Advisory Notice for Titan T-51 Mustang Aircraft

March 4th, 2020

Inspection required before any further flights

Fig 1

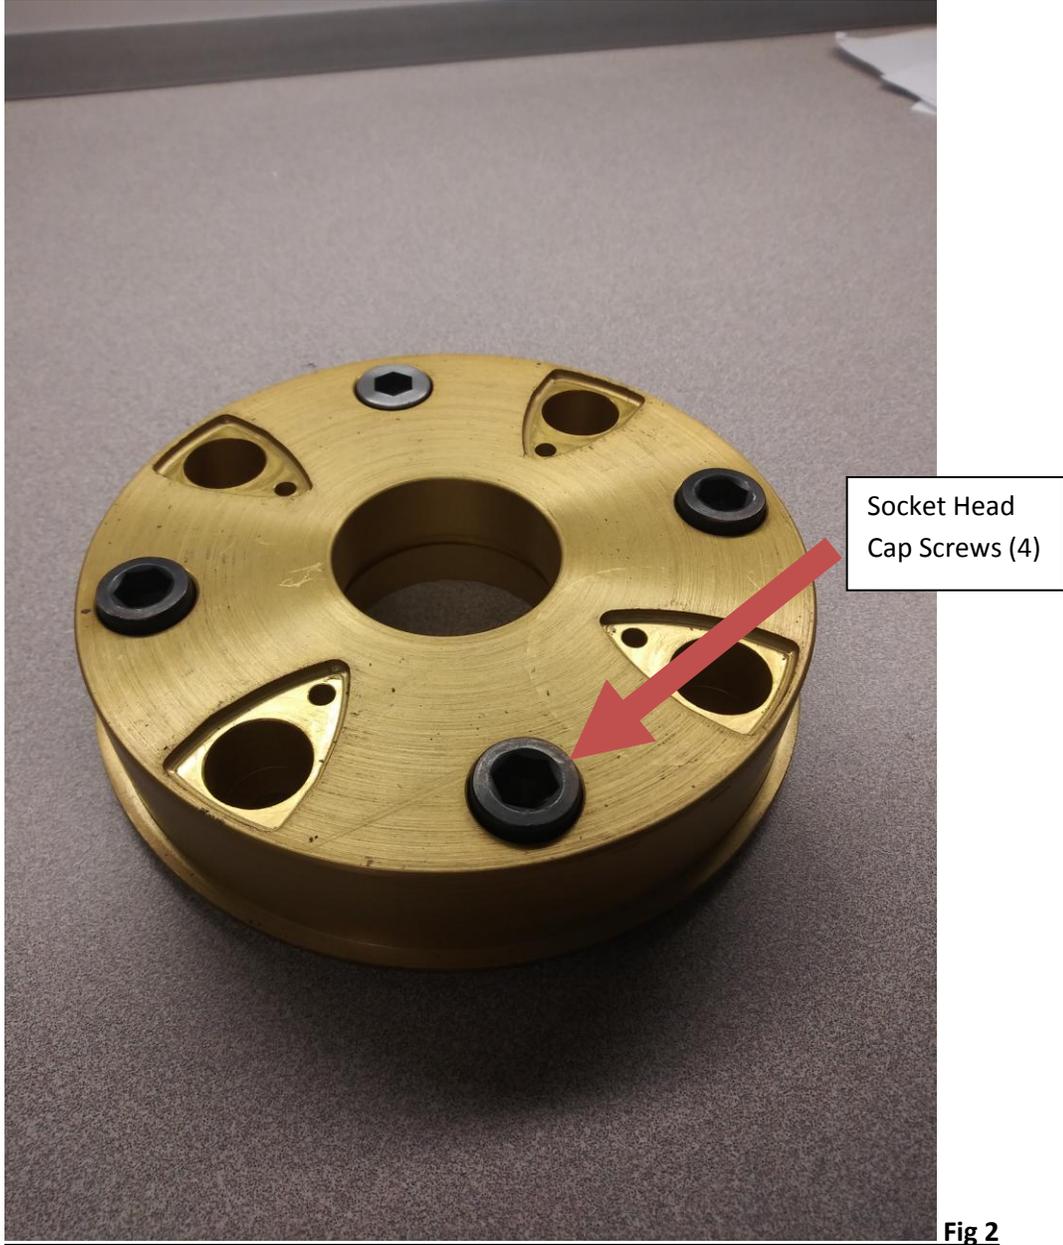
When the Elastomeric coupler is installed it may come in contact with the socket headed cap screws that secure the adaptor plate to the fly wheel (see fig 2) . This changes the installation height which in turn puts lateral pressure on the engine crank shaft which may result in excessive wear on the crank shaft thrust bearing. Which in extreme cases may result in engine damage.

Fig 2

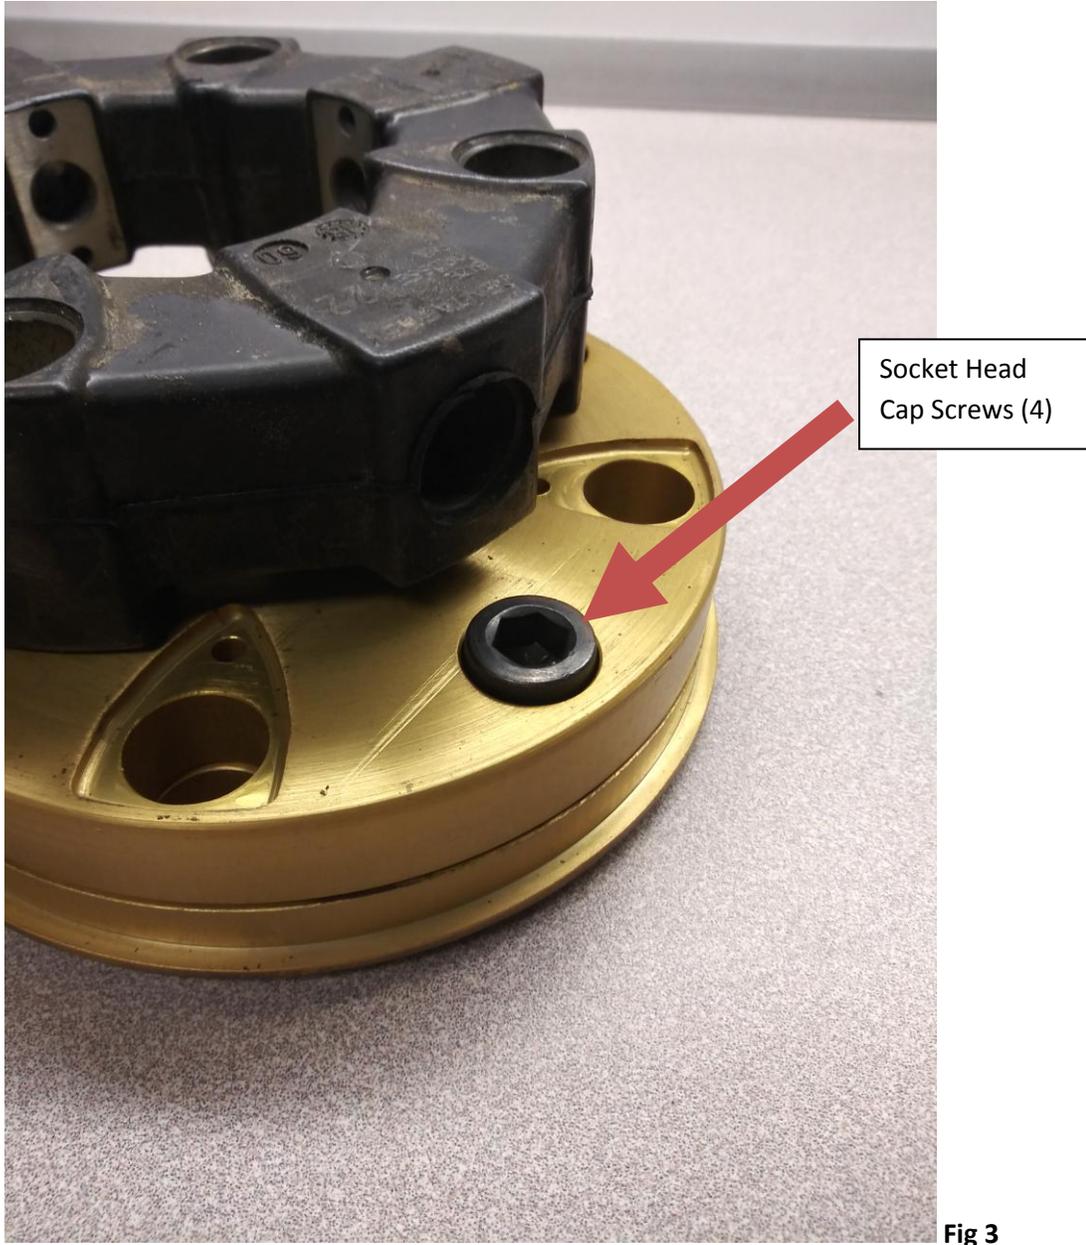
UNMODIFIED BOLT HEAD CLEARANCE

Remove the gearbox from the aircraft and remove the Bolts in question. Then Machine 1/8" off the Cap screw bolt heads. Then reinstall the Bolts. This will provide adequate clearance between the bolt heads and the elastomeric coupler.
